## AGENDA

### PLANNING & ZONING COMMISSION REGULAR MEETING TUESDAY, NOVEMBER 19, 2024 - 3:30 PM MCALLEN CITY HALL, 1300 HOUSTON AVENUE CITY COMMISSION CHAMBERS, 3<sup>RD</sup> FLOOR

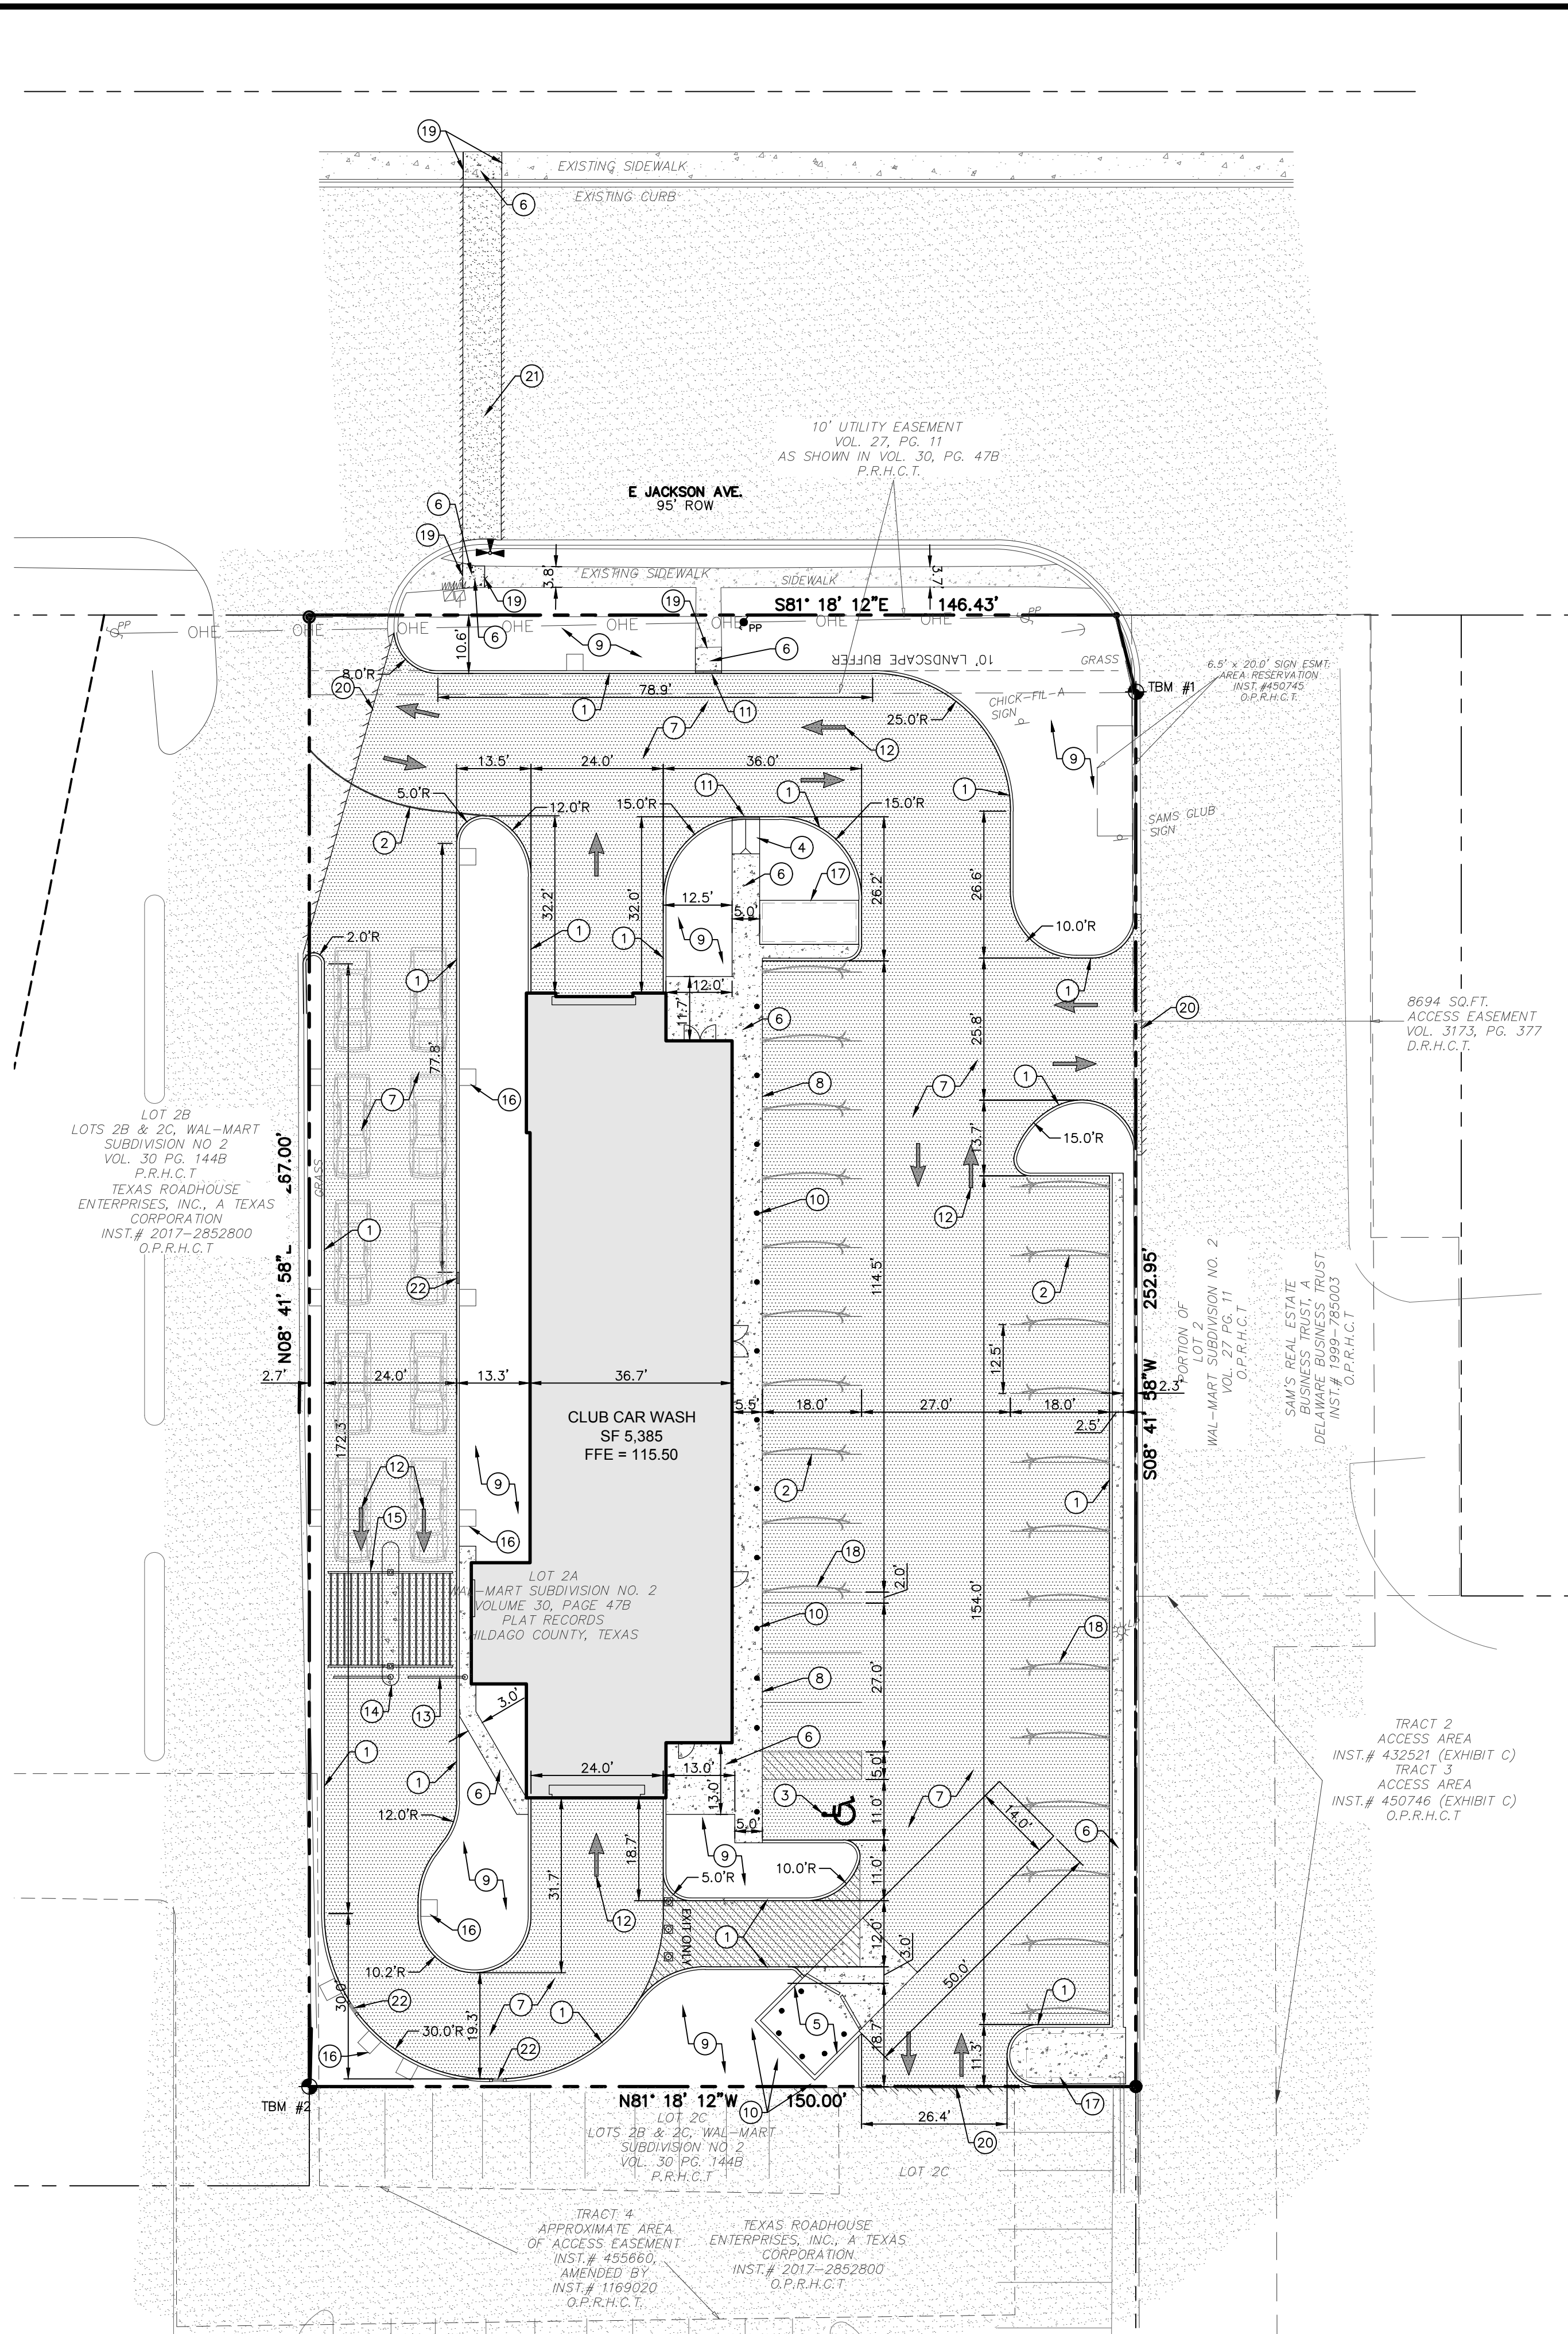
Other Planning Requirements:

There is a 50-foot front yard setback and 10 foot utility easement along East Jackson Avenue, the rear yard setback and side yard setbacks as per Zoning Ordinance or greater for approved site plan or easements. No structures are permitted to be built over any easements. The new development will be complying with all required setbacks for the property.

A 4-foot-wide minimum sidewalk is required along East Jackson Avenue.

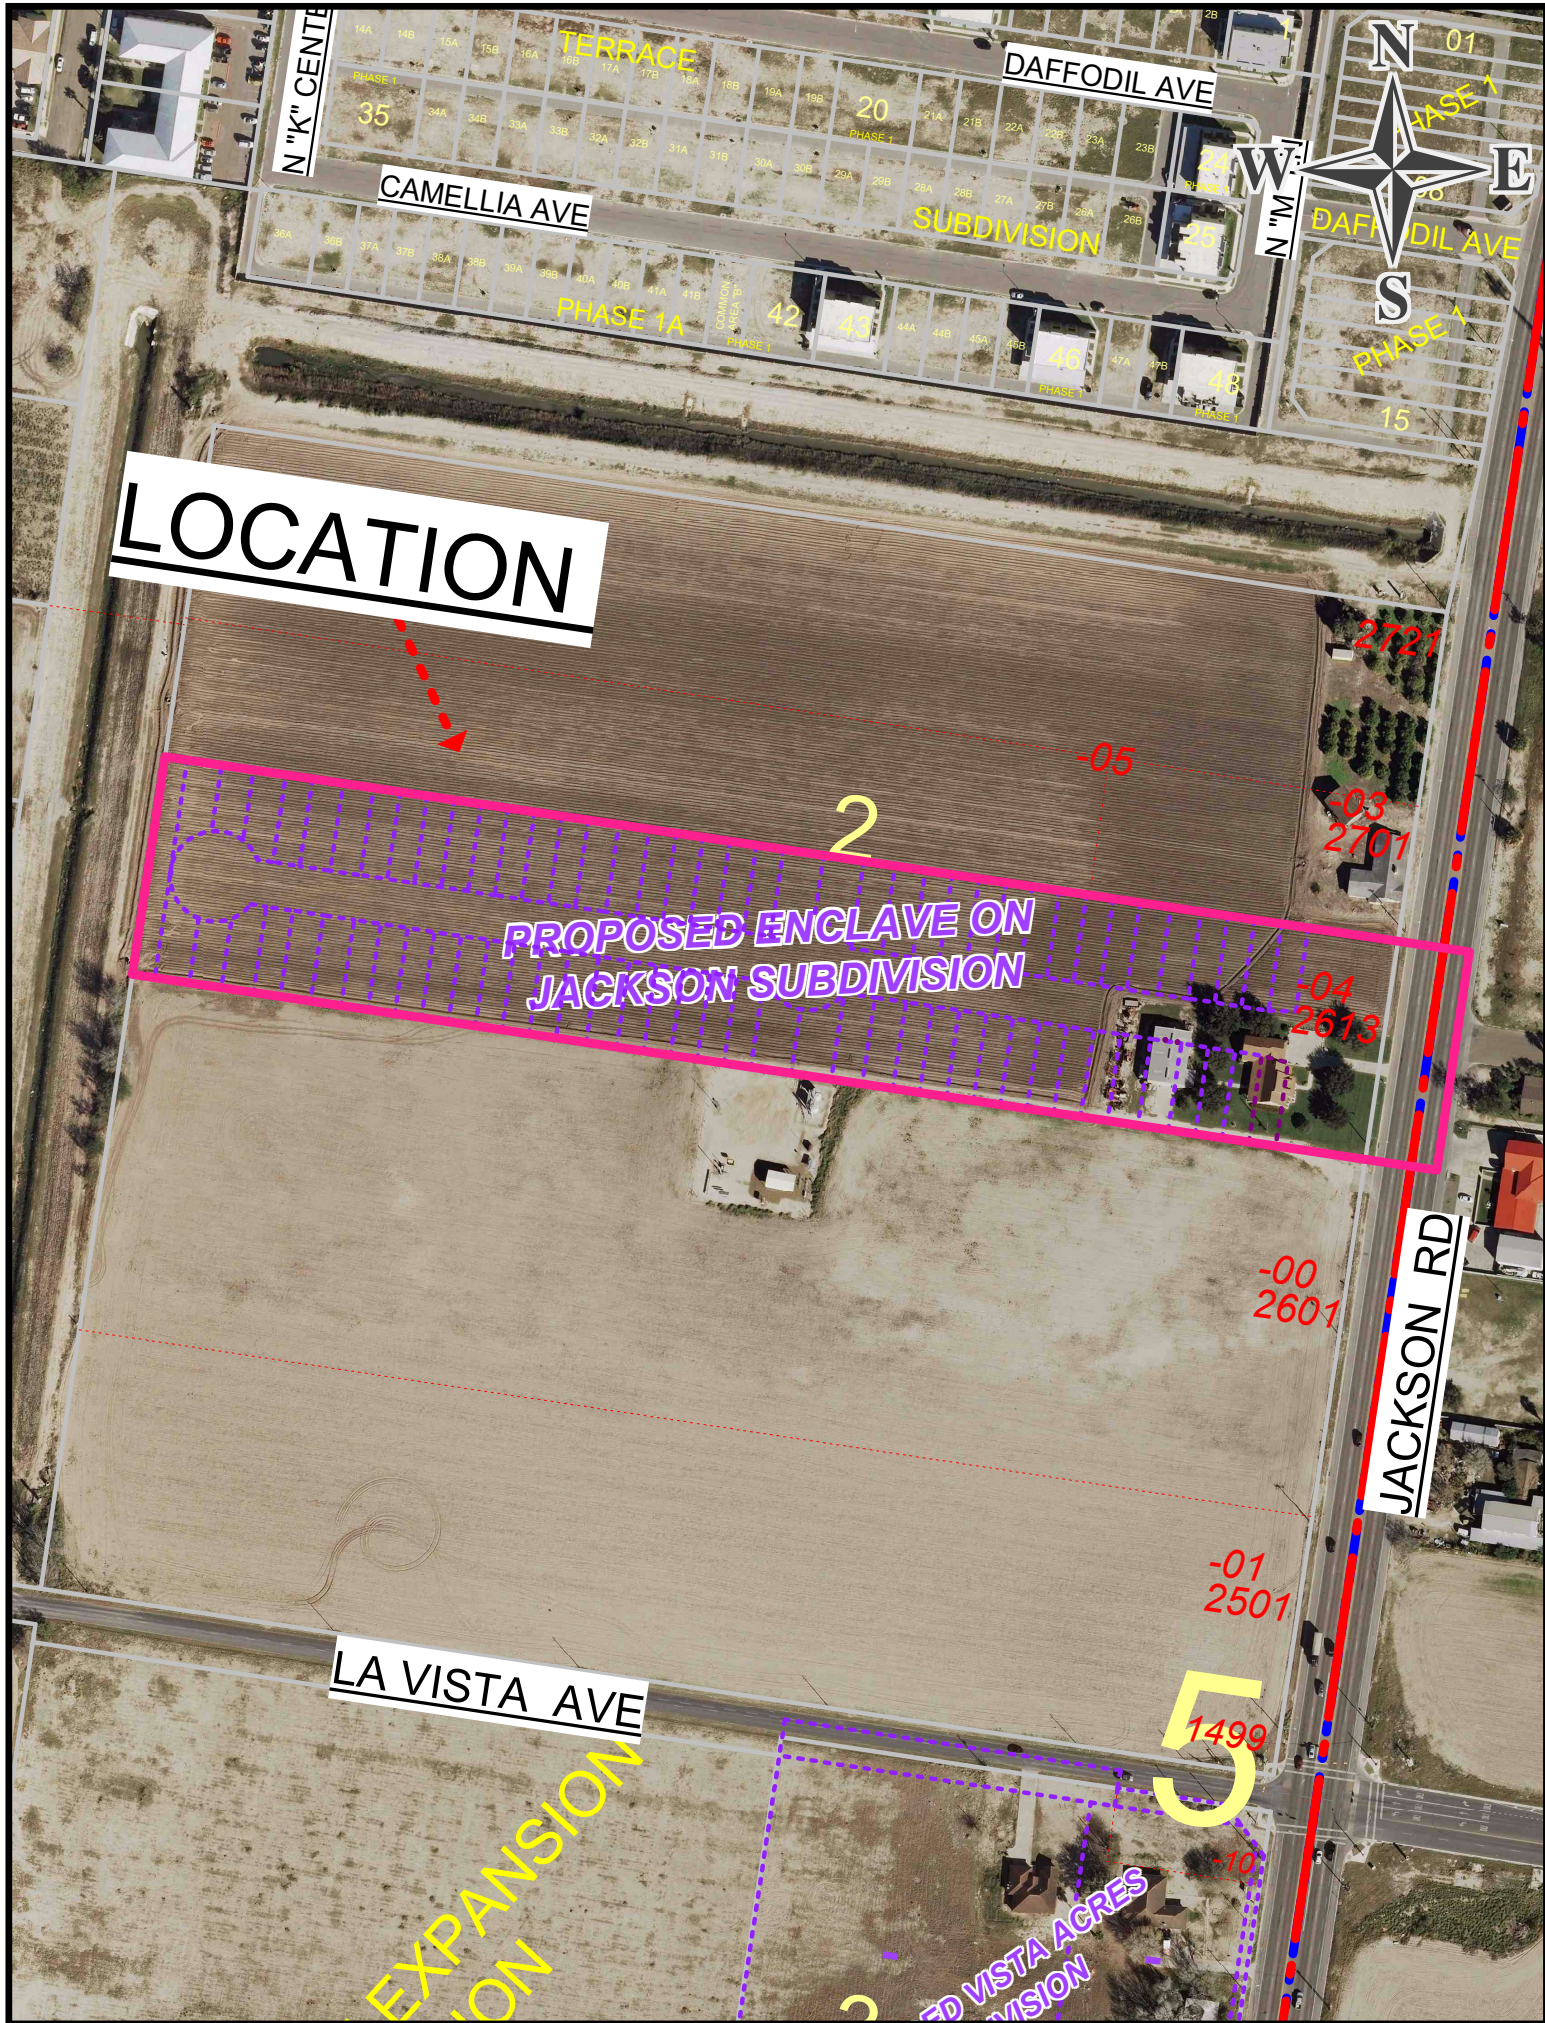
<ul style="list-style-type: none"> <li>* Common Areas for commercial developments provide for common parking, access, setbacks, landscaping, etc.</li> </ul>	NA
<ul style="list-style-type: none"> <li>* Developer/Homeowner's Association/Owner, their successors and assignees, and not the City of McAllen shall be responsible for compliance of installation and maintenance and other requirements per Section 134-168 of the Subdivision Ordinance, including but not limited to common areas and its private streets.</li> <li>**Section 110-72 applies if public subdivision is proposed.</li> <li>**Landscaping Ordinance: Section 110-72</li> <li>**Subdivision Ordinance: Section 134-168</li> </ul>	Applied

<ul style="list-style-type: none"> <li>* Homeowner's Association Covenants must be recorded and submitted with document number on the plat, prior to recording.</li> <li>- Submit a copy of the draft HOA document prior to recording.</li> <li>**Section 110-72 applies if public subdivision is proposed.</li> <li>**Section 134-168 applies if private subdivision is proposed.</li> <li>**Landscaping Ordinance: Section 110-72</li> <li>**Subdivision Ordinance: Section 134-168</li> </ul>	Required
<b>LOT REQUIREMENTS</b>	
<ul style="list-style-type: none"> <li>* Lots fronting public/private streets</li> <li>**Subdivision Ordinance: Section 134-1</li> </ul>	Applied
<ul style="list-style-type: none"> <li>* Minimum lot width and lot area</li> <li>- The proposed lots do not meet the minimum Lot width and size requirement for the current zone (A-O and C-3). Submit and finalize the zoning and provide the irregular lots square footages to determine compliance prior to final.</li> <li>**Zoning Ordinance: Section 138-356</li> </ul>	Non-compliance

<b>ZONING/CUP</b>	
<ul style="list-style-type: none"> <li>* Existing: A-O &amp; C-3 Proposed: R-3T</li> <li>- The rezoning must be finalized prior to final.</li> <li>***Zoning Ordinance: Article V</li> </ul>	Required
<ul style="list-style-type: none"> <li>* Rezoning Needed Before Final Approval</li> <li>- Submit rezoning and finalize prior to final.</li> <li>***Zoning Ordinance: Article V</li> </ul>	Non-compliance
<b>PARKS</b>	
<ul style="list-style-type: none"> <li>* Land dedication in lieu of fee.</li> <li>- Based on the submitted application and plat, 78 townhomes are proposed. As per Parks Department, park land dedication of 1.24 acres will be required prior to final. If park fee in lieu of park land dedication is proposed, a letter must be submitted to the Planning Director and reviewed by the City Manager prior to final.</li> </ul>	Required
<ul style="list-style-type: none"> <li>* Park Fee of \$700 per lot/dwelling unit to be paid prior to recording.</li> <li>- Based on the submitted application and plat, 78 townhomes are proposed. As per Parks Department, park land dedication of 1.24 acres will be required prior to final. If park fee in lieu of park land dedication is proposed, a letter must be submitted to the Planning Director and reviewed by the City Manager prior to final.</li> </ul>	Applied

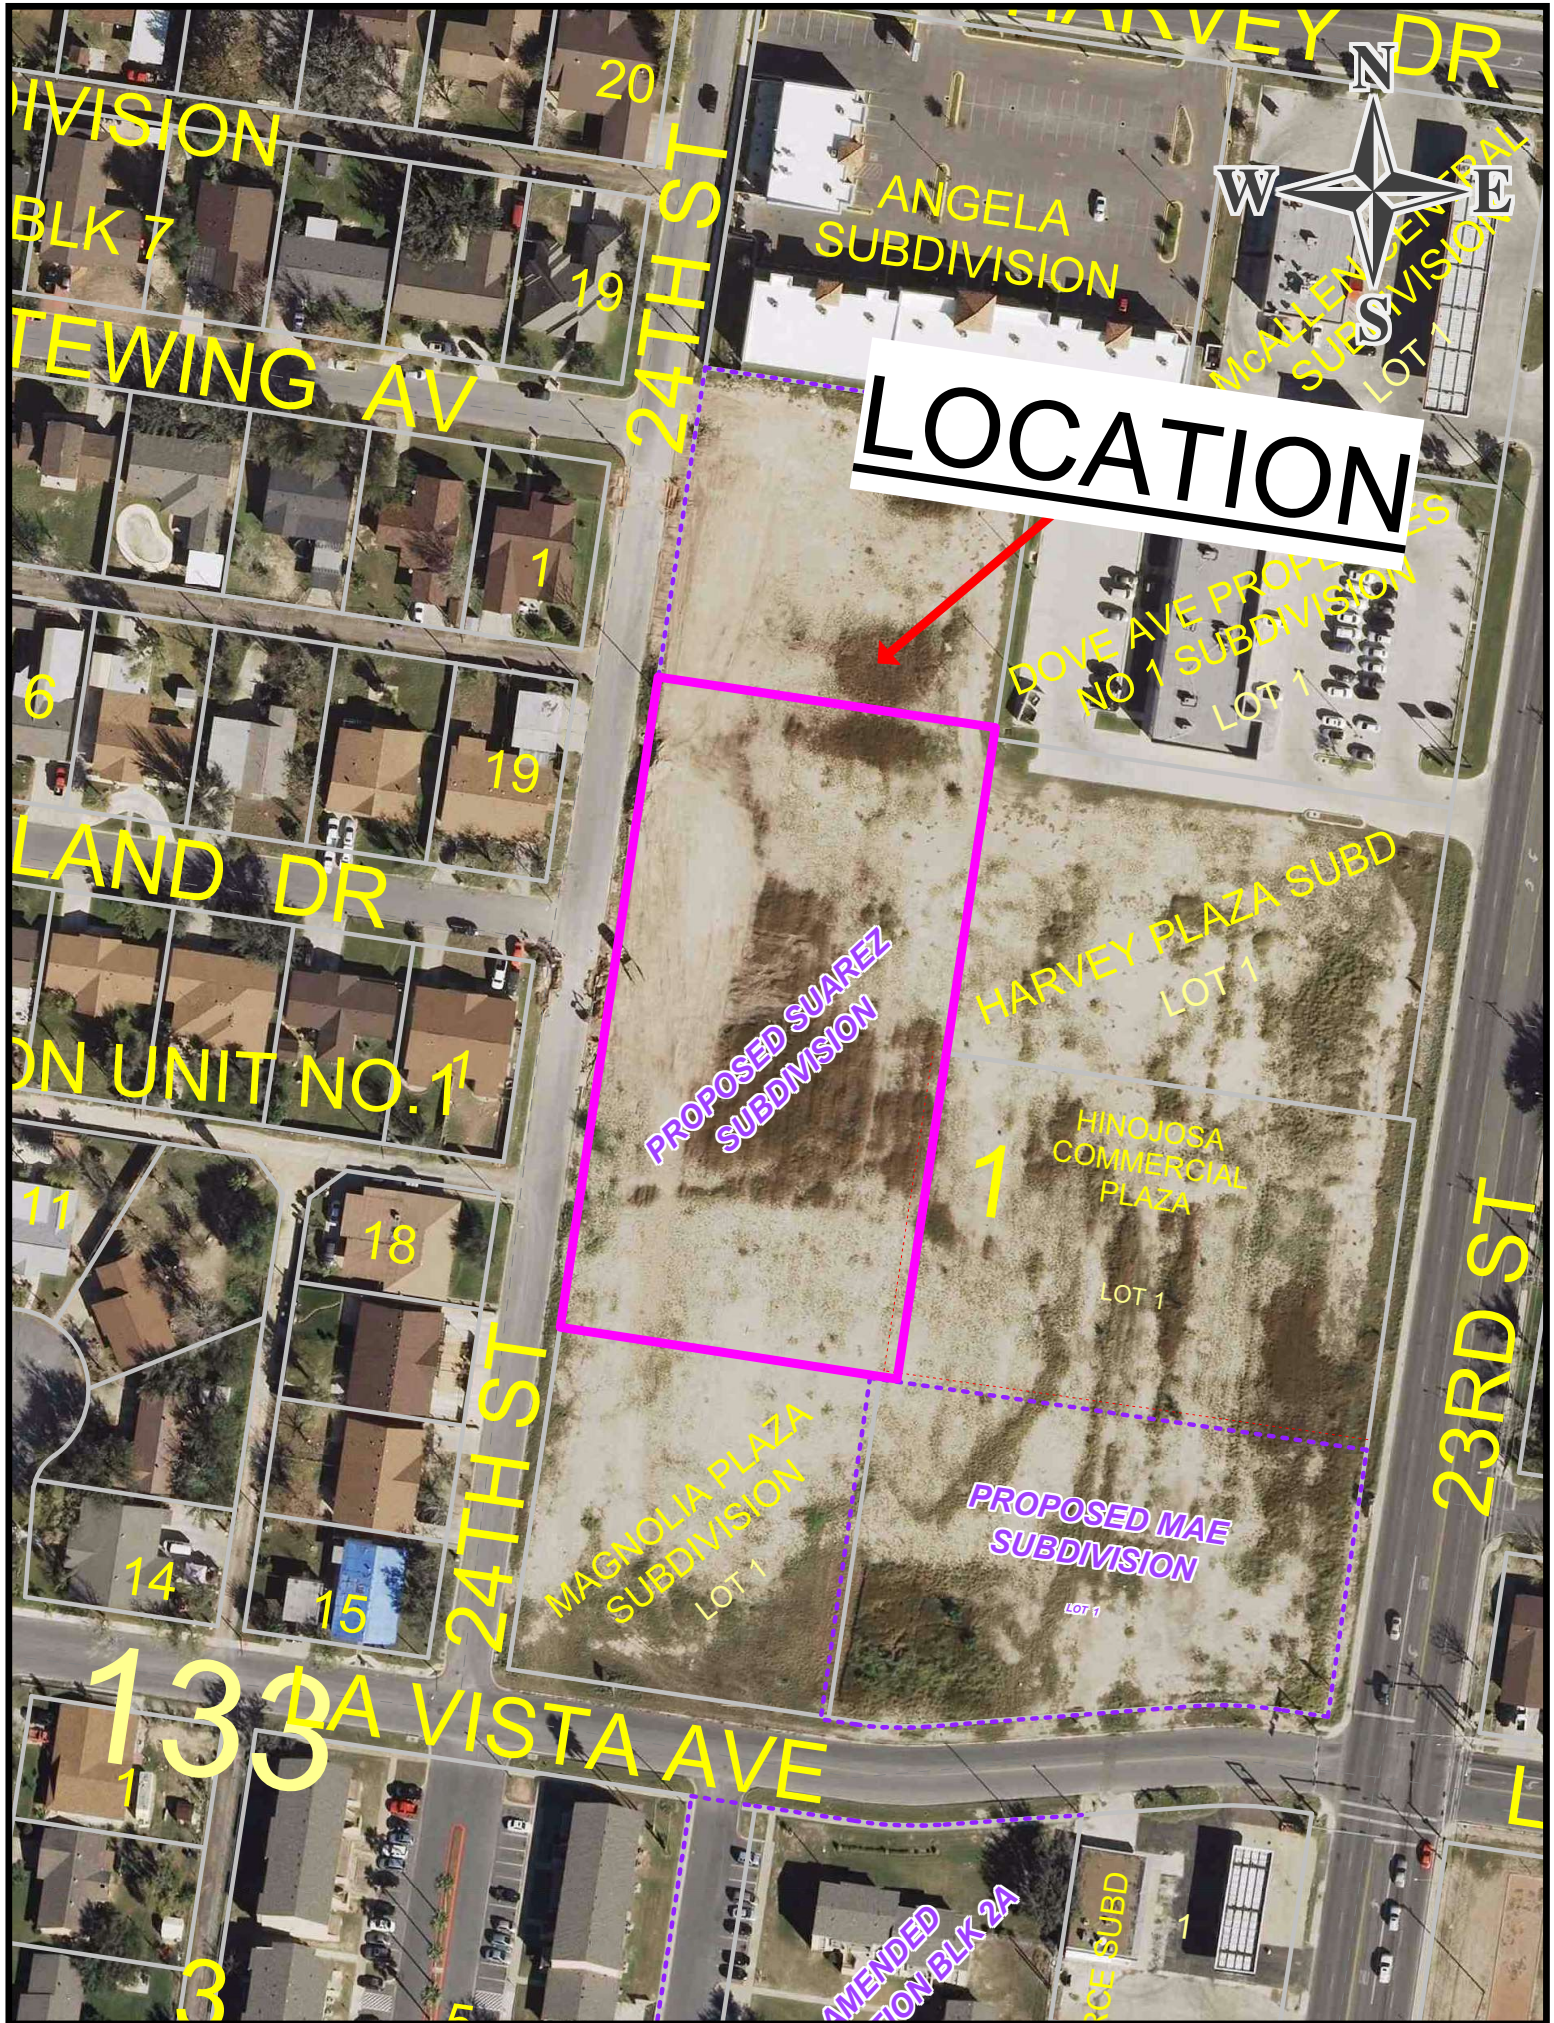
**These comments are for subdivision requirements only – additional requirements may apply at time of site plan review**

<p>* Sides: In accordance with the Zoning Ordinance or greater for easements or approved site plan, whichever is greater applies. -Revise note as shown above prior to final. **Proposing In accordance with zoning ordinance, or greater for easements or approved site plan. ***Zoning Ordinance: Section 138-356</p> <p>* Corner **Zoning Ordinance: Section 138-356</p> <p>* Garage **Zoning Ordinance: Section 138-356</p> <p>*ALL SETBACKS ARE SUBJECT TO INCREASE FOR EASEMENTS OR APPROVED SITE PLAN</p>	Non-compliance
	NA
	NA
	Applied
<b>SIDEWALKS</b>	
<p>* 4 ft. wide minimum sidewalk required on North 24th Street - Proposing: A 5 ft. sidewalk shall be required along the east side of N. 24th Street - Sidewalk requirements may increase to 5 ft. per Engineering Department **Subdivision Ordinance: Section 134-120</p> <p>* Perimeter sidewalks must be built or money escrowed if not built at this time.</p>	Applied
